# Proposed Amendments to Partially Operative Selwyn District Plan

The base version is the Appeals Version of the PODP as released by Selwyn District Council on 6 December 2023. Only those provisions of the PODP that are subject to amendment have been included.

**Amend** the Planning Maps to rezone the property at 157 Levi Road (Lot 1 Deposited Plan 579376) from Medium Density Residential Zone (MRZ) to Large Format Retail Zone (LFRZ).

Zone Layer

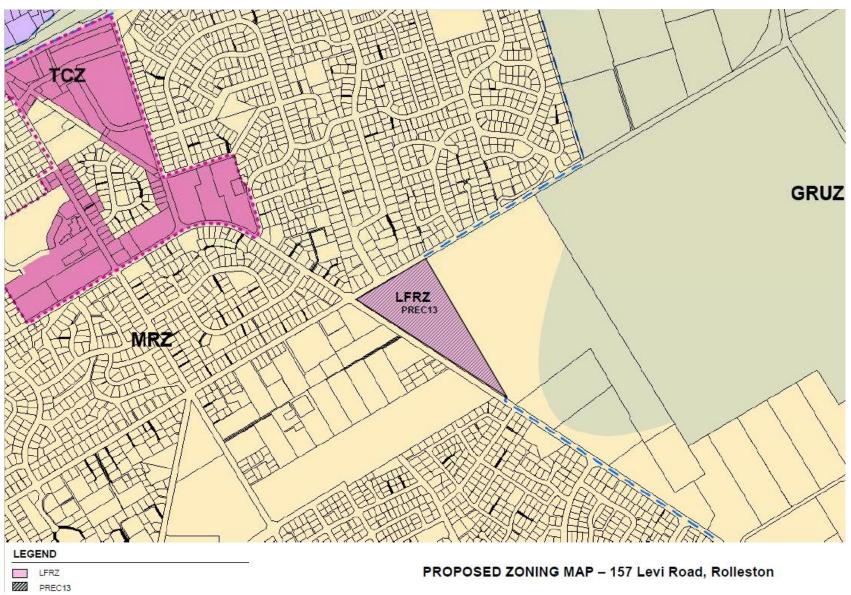
Delete DEV-RO1 Rolleston 1 Development Area (Lot 1 Deposited Plan 579376).

Add Lincoln Rolleston Road Large Format Retail Precinct on the property at 157 Levi Road (Lot 1 Deposited Plan 579376).
